City of Richmond
Planning and Development Department

Report to Development Permit Panel

To: Development Permit Panel
From: Jean Lamontagne
Director of Development
Date: March 13, 2007
File: DP 06-330668
Re: **Application by Island City Builders Ltd. for a Development Permit at
5280 Williams Road**

Arboriculture Assessment

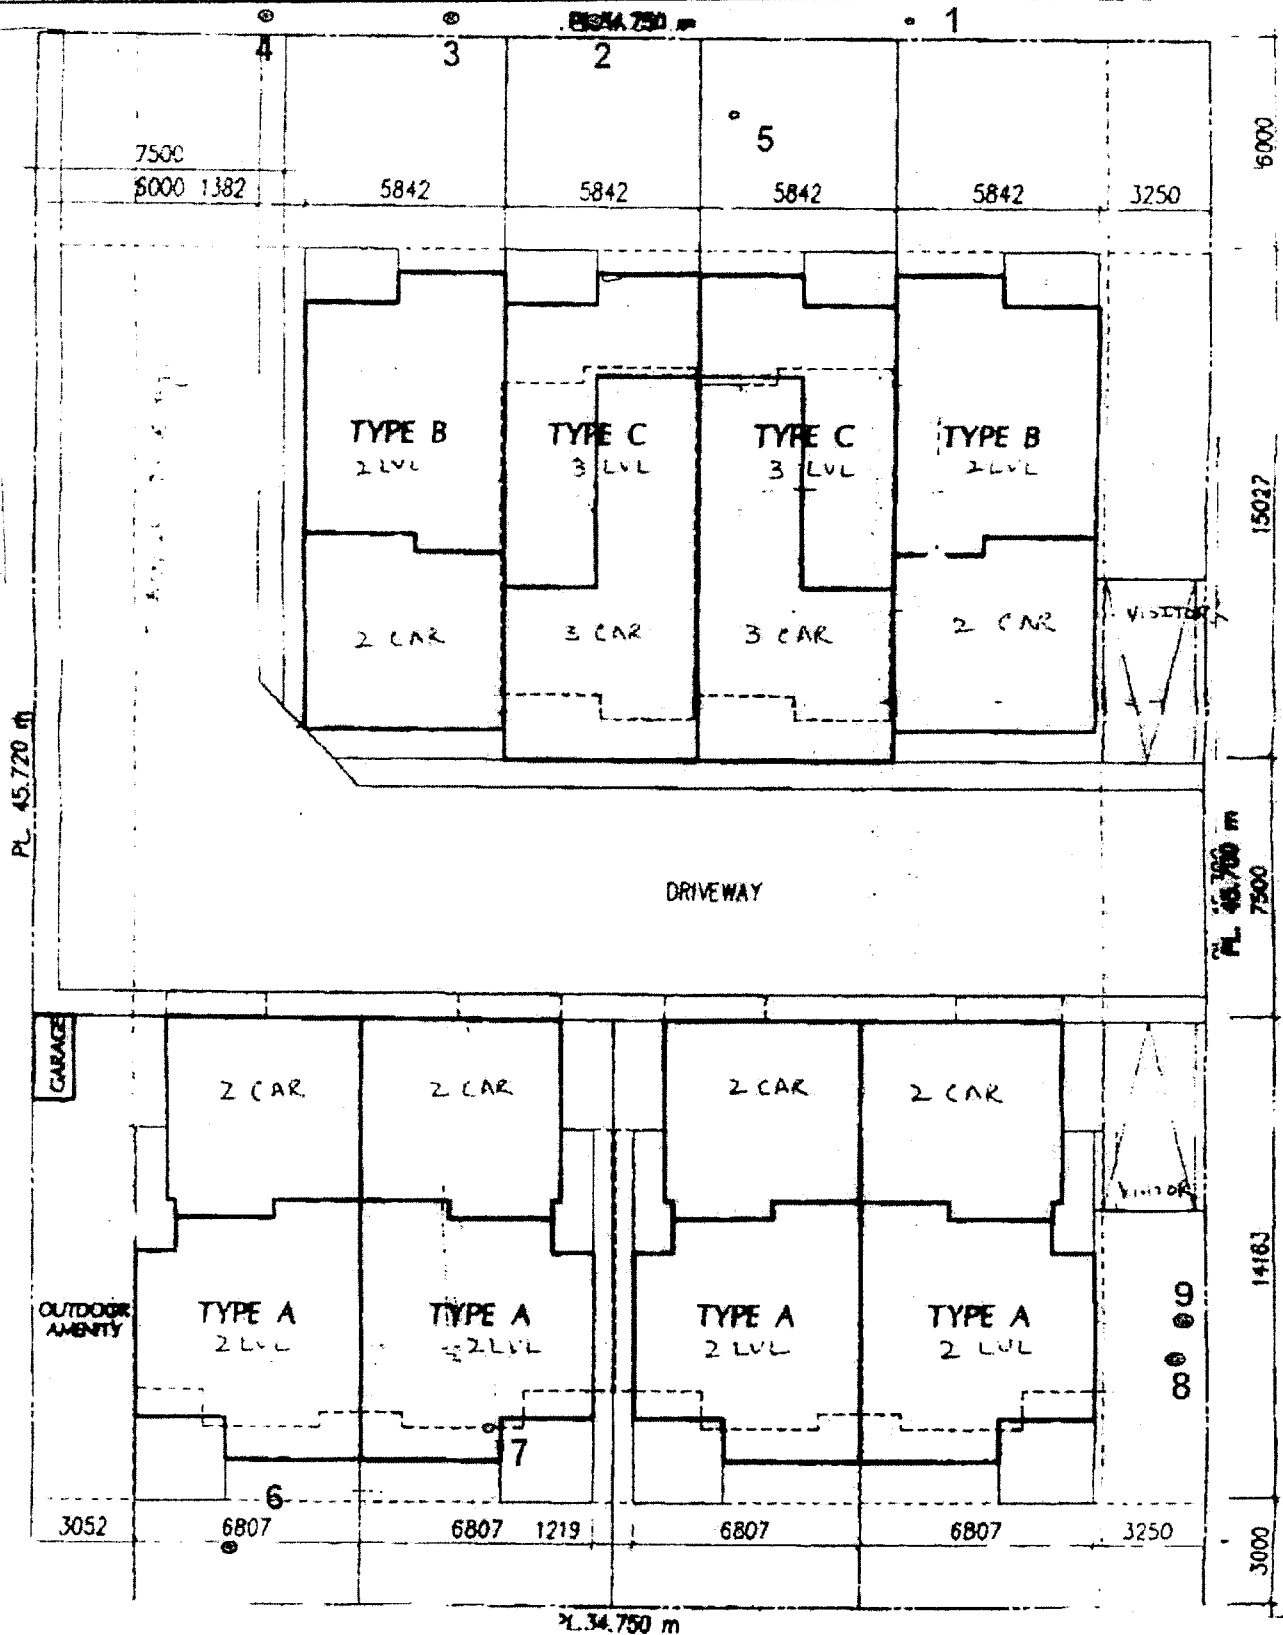
Summary of Findings	Totals
Number of trees identified on the proposed development site (Does not include trees on city property)	5
Number of "major trees" (greater than 20cm dbh) found at the proposed development to be removed. (good healthy specimens)	1 (Tree #6)
Number of "minor trees" (less than 20cm dbh) found at the proposed development to be removed (good healthy specimens)	1 (Tree #7)
Number of "major trees" (greater than 20cm dbh) that do not contain significant defects that make them unsuitable for future retention, but are within the proposed development limits.	1 (Tree #6)
Number of "minor" trees (less than 20cm dbh) that do not contain significant defects that make them unsuitable for future retention, but are within the proposed development limits.	1 (Tree #7)
Number of trees to be retained.	3 (Trees 5,8,9)

Tree numbers 3, 8 and 9 can be safely retained within the proposed development site. Tree #3 will require a 2 meter tree protection zone and trees #8 and 9 will require a 3 meter tree protection zone in order to maintain the health of these trees. Trees number 8 and 9 can a crown lift where up to 50% of the live can be pruned.

Prior to demolition of the house on this property, the tree protection fencing for these trees should be installed.

Figure 1.

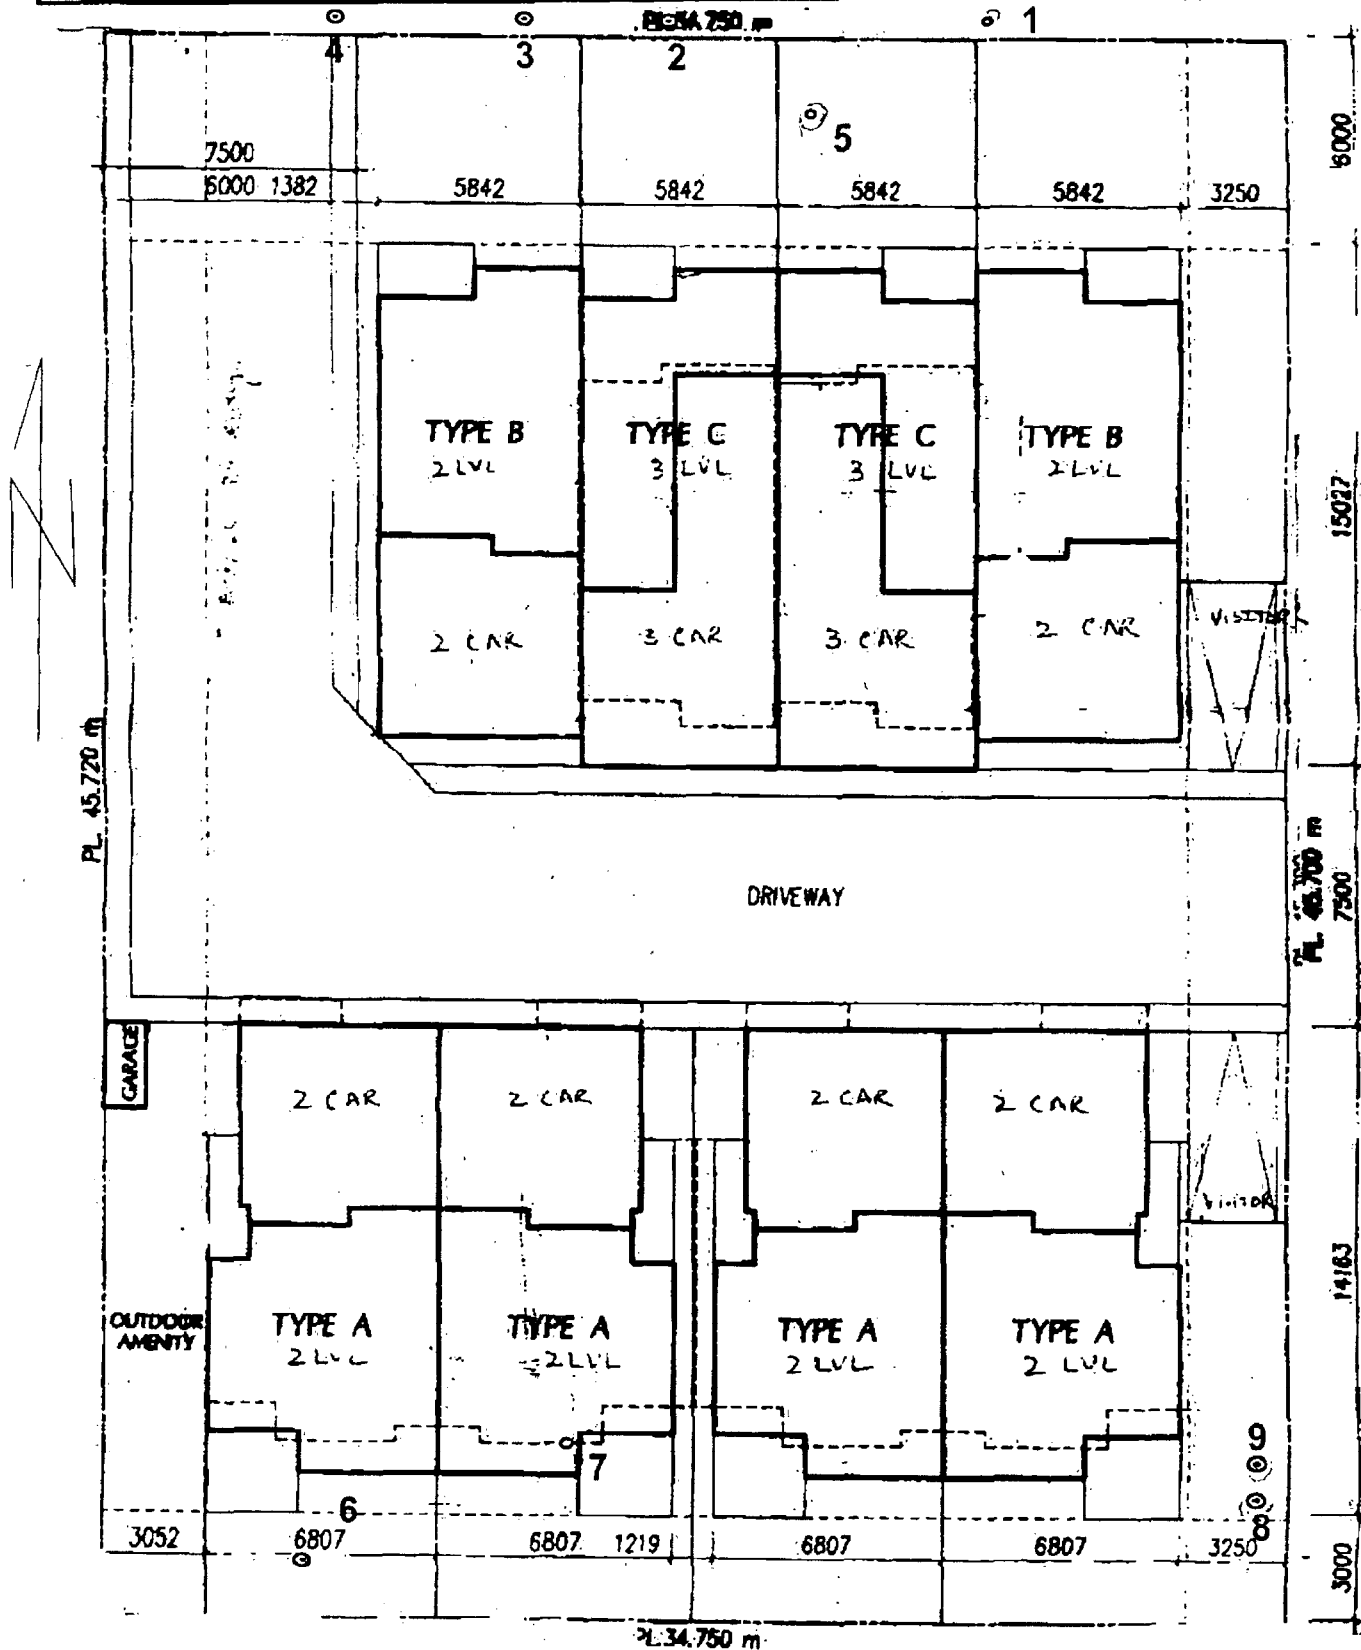
Diamond Head Consulting prepared an arborists report dated March 7, 2005 titled *Tree Assessment for the Proposed Townhouse Development at 5280 Williams Road Richmond BC*. In this report, nine trees were identified on the site and four of them were recommended for retention or for transplanting (See Figure 1 for the location of these trees with respect to the original plans). Tree #5 can be transplanted or left in its place under the new site plan. Tree #'s 6, 8 and 9 were recommended for retention under the original plans. Tree number six can also be retained under the new site plan. After revising the architectural drawings, trees eight and nine are now situated three meters from the edge of excavation for the development. This is quite close to these trees, therefore extra care will be required to ensure their survival. The following steps are recommended to make sure these two trees survive the development process:

1. Excavation work near these trees should be supervised to ensure proper care is taken and that structural roots are not impacted such that the tree would become a hazard in windy conditions.
2. Assuming no structural roots are encountered, the smaller feeder roots should be pruned at the excavation edge
3. A plywood board should be installed along the cut edge to retain soil moisture
4. The lower limbs should be lift pruned and a spiral pruning may be necessary
5. Under prolonged periods with no rain, the trees should be watered – as directed by the project arborist
6. It is assumed that tree protection fencing for this lot will follow those guidelines established by the City

If the protocol mentioned above for tree numbers eight and nine are followed, there is a high likelihood that these trees will survive the impacts from the development.

Figure 1. Revised Site Plans, Tree Locations & Tree Protection Zones (TPZ) at 5280 Williams Road, Richmond, BC.

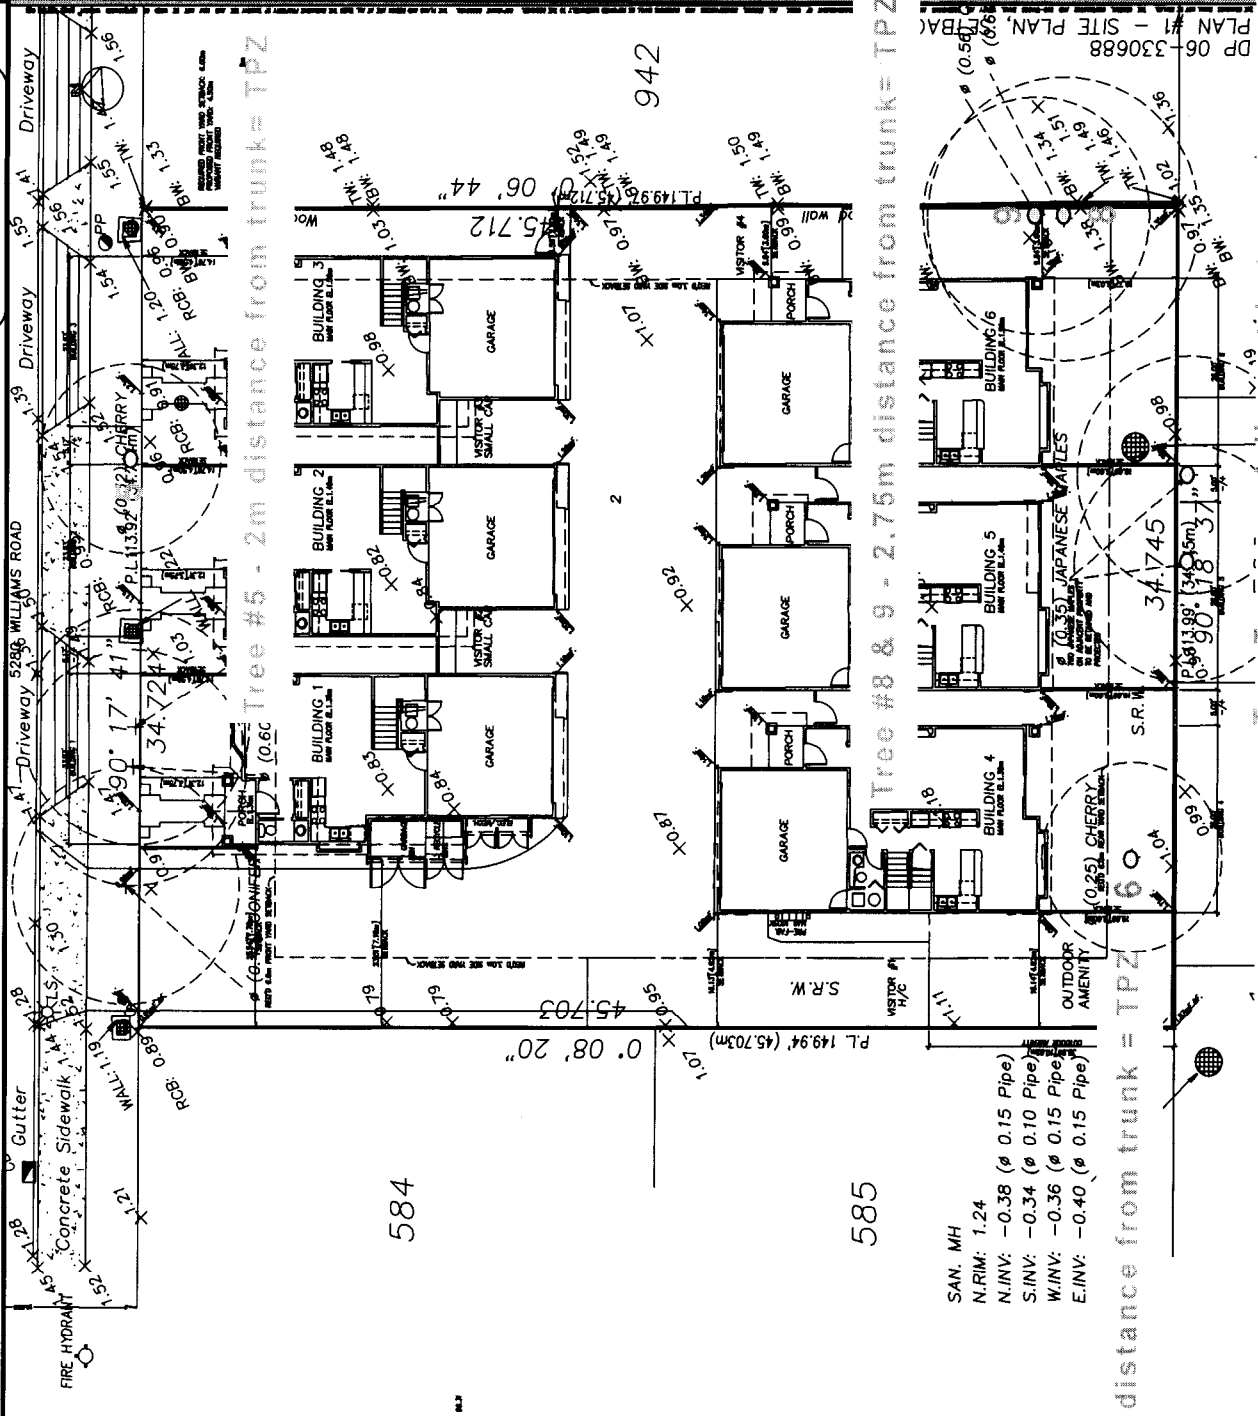
Recent changes (2007) to architectural plans prompted the City of Richmond to request further review from the project arborist. Upon our review and based on the most updated site plans (Figure 1) and existing limits of excavation, trees numbered 5, 6, 8 & 9 can be retained as per our previous recommendations. Tree eight and nine require extra care and attention with respect to the tree protection measures due to the proximity of their roots to the construction activities. From the architectural drawings, it appears that the foundation of the nearest home is 3 meters out from the east property line and 4.5 meters from the southern property line. An additional distance of 0.6 meters width by 0.6 meters depth is required for drainage at the foot of the foundation. Tree # 8 and 9 are at the greatest risk of being impacted from these activities and therefore need as much of the 3-meter distance from their trunks to the excavation protected. It is recommended that a protection area measuring 2.75 meters out from their trunks be created. This protection area will not permit the additional .6 meters of excavation for drainage. Alternatives to drainage in this area are recommended such as tunneling under the roots or omitting the drainage in this specific location. Tree protection for trees # 5 & 6 should measure 2 meters out from their trunks.

The establishment of a tree protection bylaw in the City of Richmond requires trees on neighbouring properties to be protected from construction activities. In this case two trees south of the development will require protection as their roots extend on to the subject site. A tree protection area measuring 2 meters out from the fence will be required for these trees.

Four trees on site and two trees off site (south) will require tree protection fencing installed to protect them from construction activities. The health, safety and survival of these trees are

1. Install tree protection fencing around the following trees at the following distances (determined by the project arborist).
 - a. Tree # 5 (8 cm dbh) – 2 meters distance out from trunk
 - b. Tree # 6 (25 cm dbh) – 2 meters distance out from trunk
 - c. Tree # 8 (56 cm dbh) – 2.75 meters distance out from trunk
 - d. Tree # 9 (48 cm dbh) – 2.75 meters distance out from trunk
 - e. Trees (2) on adjacent lot to south (35 cm dbh) – 2 meters distance from property line.

4. Excavation work near these trees will have to be supervised to ensure proper care is taken during the excavation and that structural roots are not impacted such that the tree would become a hazard in windy conditions.

5. Assuming no structural roots are encountered, the smaller feeder roots should be pruned at the edge upon excavation by the project arborist.
6. A plywood board should be installed along the cut edge to retain soil moisture.

7. Drainage installation at excavation limits should be **avoided or tunneled** beneath the trees to avoid root damage within the tree protection zone. Any construction activities planned within this area must be designed and constructed carefully as to have no short or long term impacts on the subject trees. These designs must be reviewed and supervised by the consulting arborist.

**Figure 2. Tree Protection Fence Detail
5280 Williams Road, Richmond BC.**

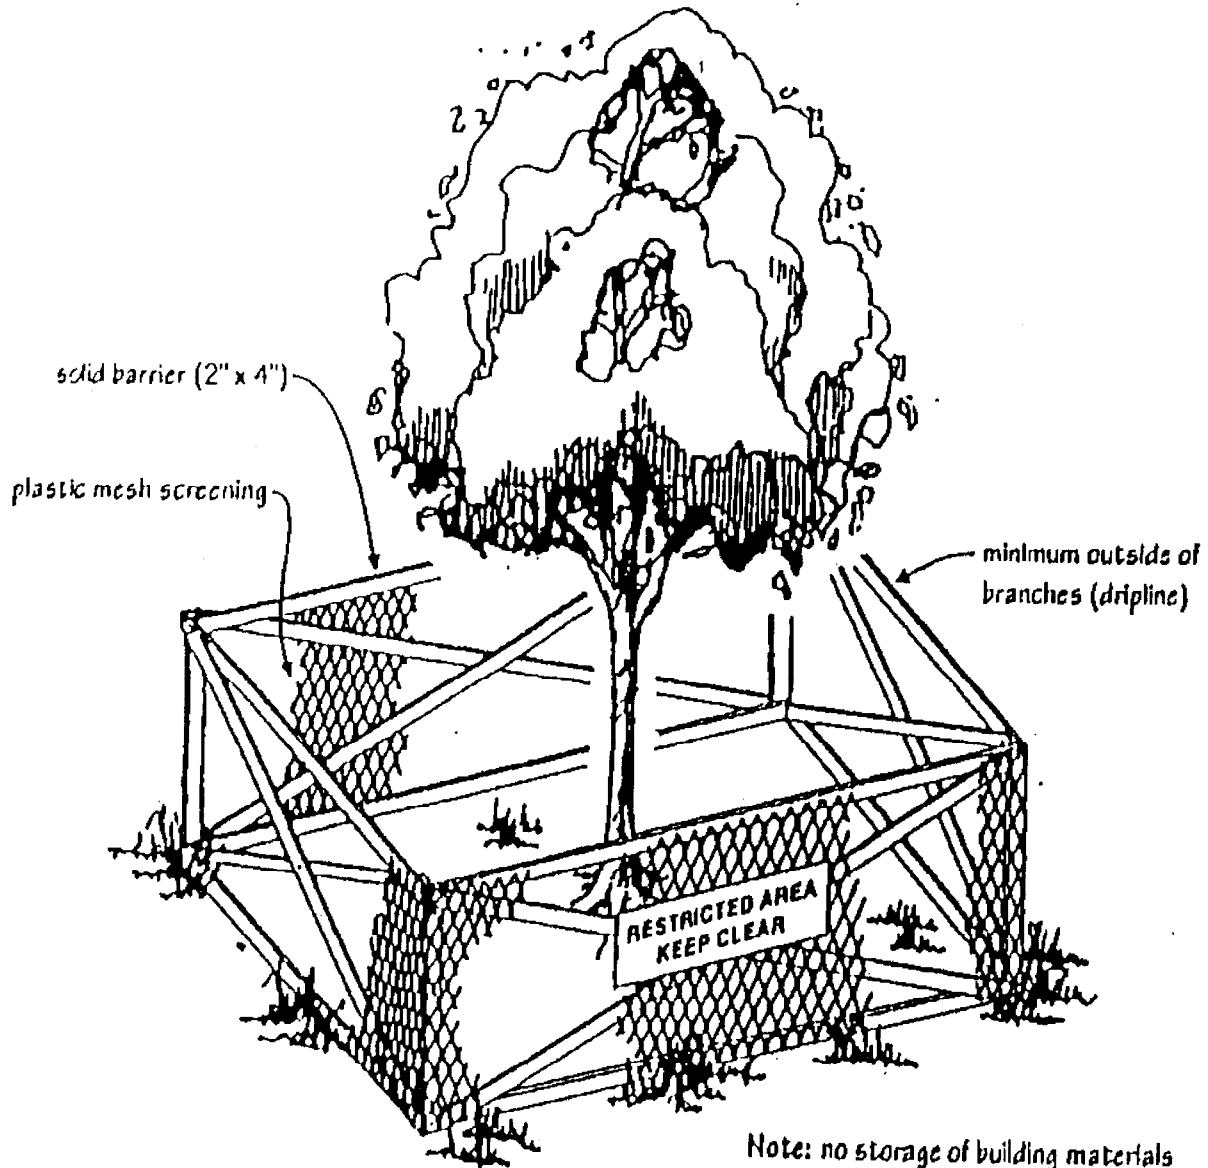
*Note: no storage of building materials
within or against protection barrier*

DP 06-330688
 PLAN #1a - SITE PLAN, SETBACKS (GROUND FLOOR)

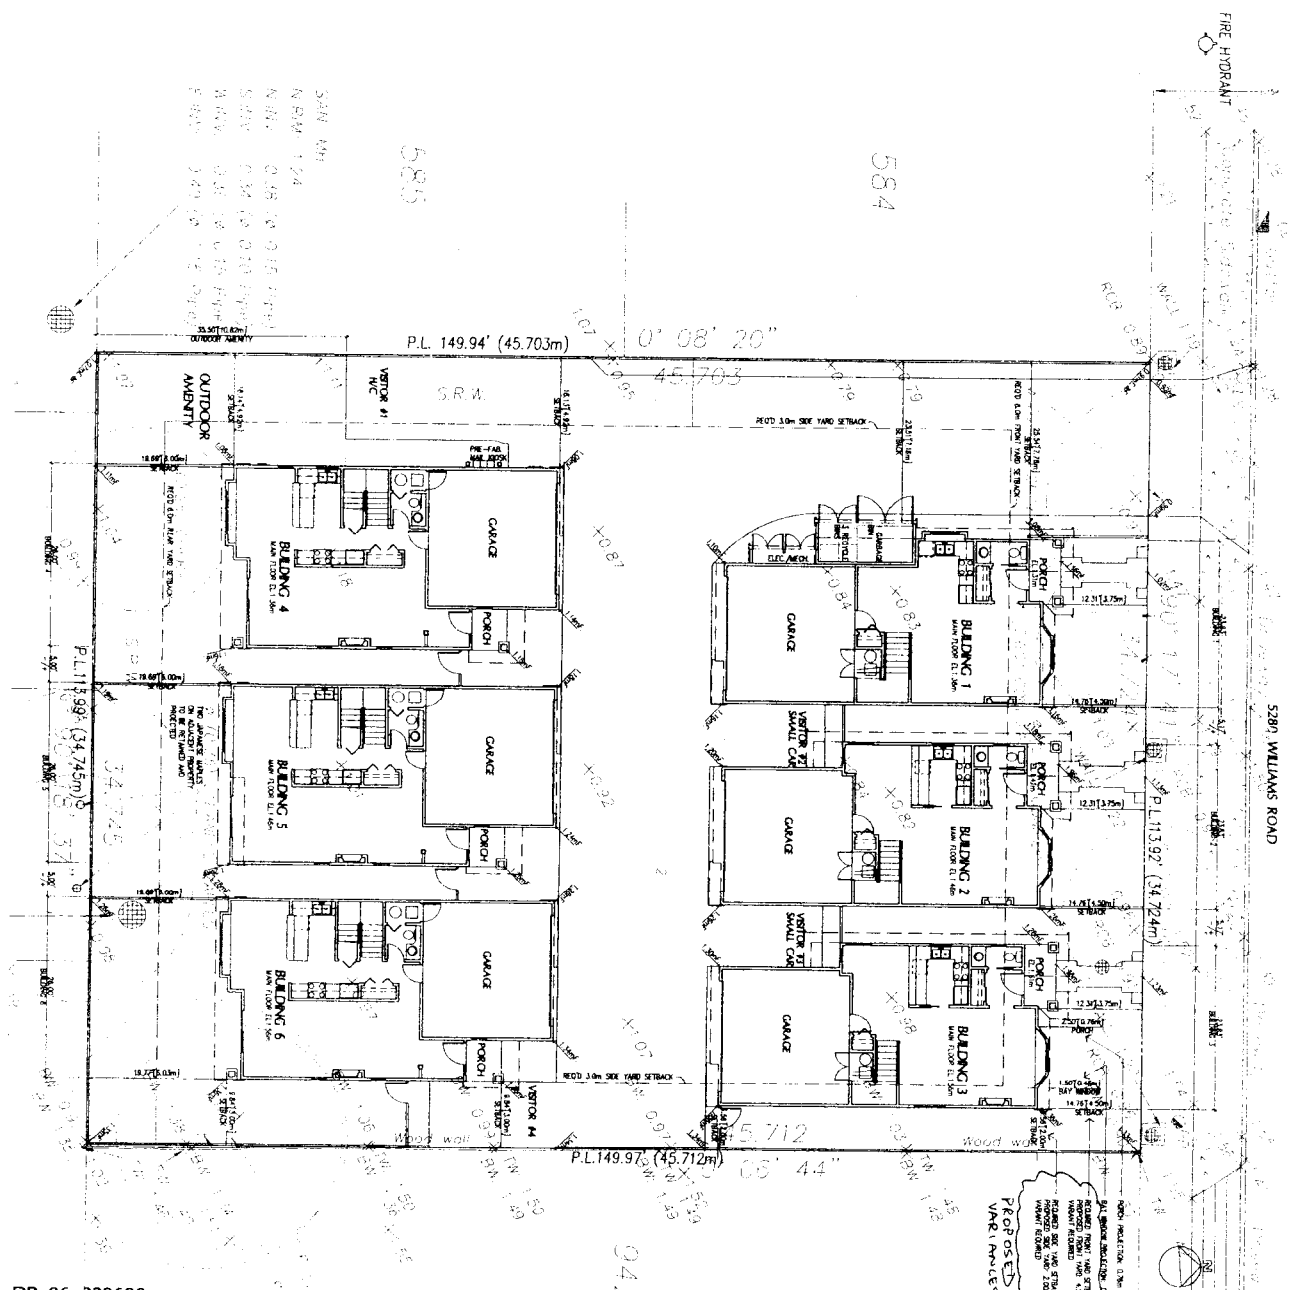
- 1) Reduce the minimum front yard setback along Williams Road from 6.0 m to 4.5 m.

(Staff supports the proposed variance as it results from measures taken to fit into the surrounding context and improve the transition to the single-family home behind. The proposed building height is limited to two-storey and the rear yard setback is increased from 3.0 m to 6.0 m. The proposed front yard setback is 4.5 m to the building face and 3.75 m to the porch which provides desirable proportionate building and streetscape articulation. The variance was identified on the preliminary drawings attached to the Report to Committee during rezoning and received no public concerns).

- 2) Reduce the east side yard setback from 3.0 m to 2.0 m for the northeast unit.

(Staff supports the proposed variance as it is the result of developing two-storey townhouses with an access on this narrow, constrained lot between two (2) newer single-family homes along an arterial road. The proposed reduced east side yard setback enables fulfillment of two (2) extra visitor parking stalls within this small site and the resulting 2.0 m setback is considered consistent with single-family type housing. The reduced side yard setback to the east adjacent to an existing single-family home was identified on the preliminary drawings attached to the Report to Committee and received no public concerns.)
